Service Work Instruction	
<b>KHC00003X to KHC00003X-CV</b>	Approved by: <b>John Jennings</b>

**Service and spare parts use of KHC00003X-CV in place of KHC00003X**

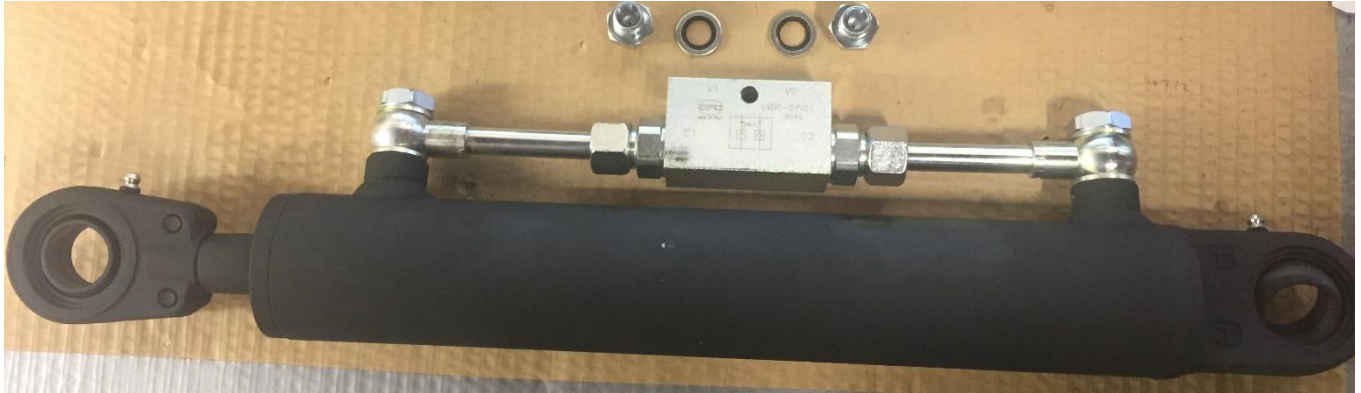
As part of a product improvement the kwicova sheeter hydraulic cylinder part number KHC00003X has been replaced with an updated system replacement part number KHC00003X-CV.

The new system replacement hydraulic cylinder part number KHC00003X-CV has additional pipe work which incorporates hose burst protection.

Please find pictures of the early design and the later design hydraulic cylinder set up.

Design to March 2020

Design from March 2020

The new system is cross compatible with the earlier design with the addition of the 1/4bsp-1/4bsp adaptor/restrictor part number 203972 and dowty washer part number 10862
